URGENT - Medical Device Correction SureSigns VS and VM Monitors & VSV – Service Guide Addendum

SureSigns VS2/VS3/VS4 Vital Signs Monitors Service Guide Addendum – Replacement for Battery Maintenance Information

This addendum replaces the “Maintaining the Battery” section in Chapter 2 of the SureSigns VS2, VS3 and VS4 Vital Signs Monitors Service Guide. Please store it with your monitor documentation. Models are listed in the table at the end of this document.

SureSigns Vital Signs ViewStation Service Guide Addendum Replacement for Battery Maintenance Information

Figure 3 Battery Info Screen

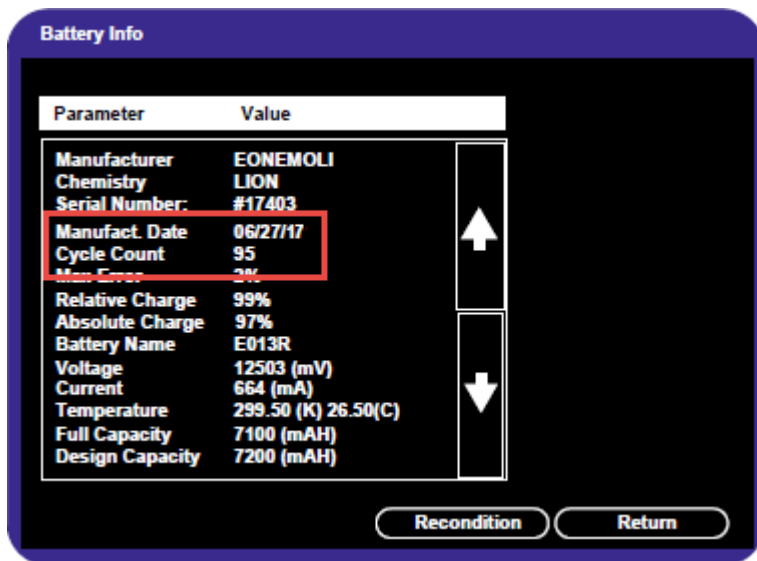
If the battery cycle count exceeds the recommended limit of **300 cycles**, or if the battery is older than **three (3) years**, the battery will need to be replaced (see Figure 3).

The risk of battery failure increases with age, when a battery remains in use past 300 charge-discharge cycles or 3 years. Such failures can result in overheating that in rare cases can cause the battery to ignite.

Figure 5 Battery product labels

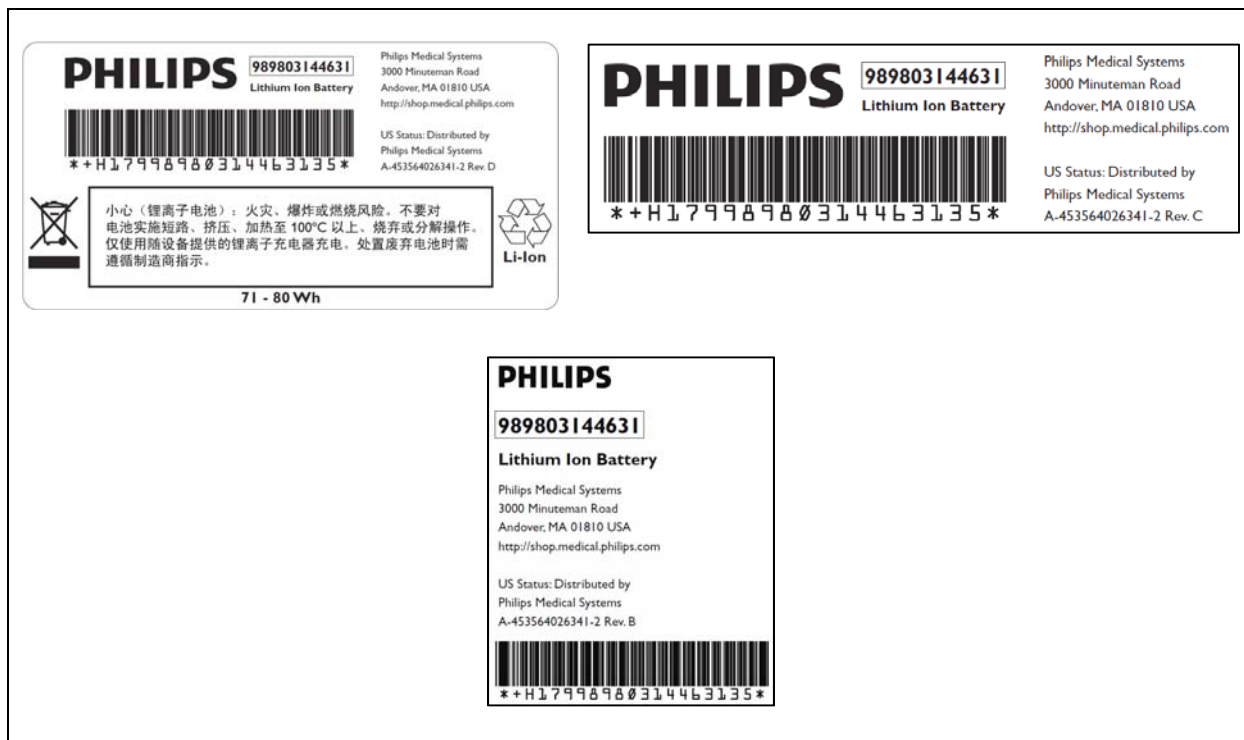
If your label looks like one of the examples in Figure 5, or any other type of label other than the label in Figure 4, you will need to replace the battery.

Figure 3 Battery Test Screen

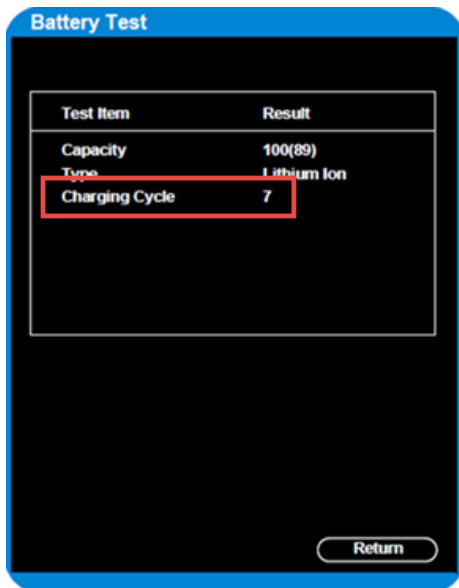
The **Battery Test** screen provides detailed information about battery capacity and charging status. If the charging cycle count exceeds the recommended limit of **300 cycles** or is older than **three (3) years**, the battery will need to be replaced (see cycle count in Figure 3).

The risk of battery failure increases with age, when a battery remains in use past 300 charge-discharge cycles or 3 years. Such failures can result in overheating that in rare cases can cause the battery to ignite.

Figure 5 Battery product labels

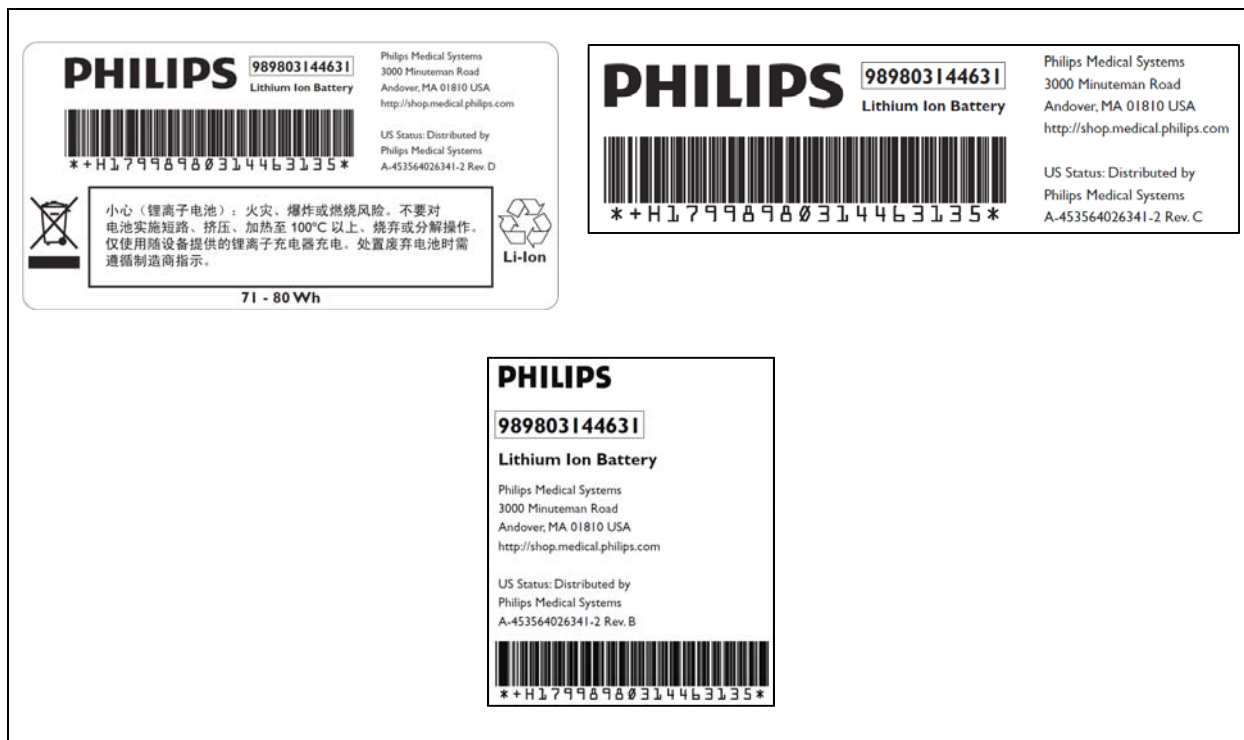
If your label looks like one of the examples in Figure 5, or any other type of label other than the label in Figure 4, you will need to replace the battery.
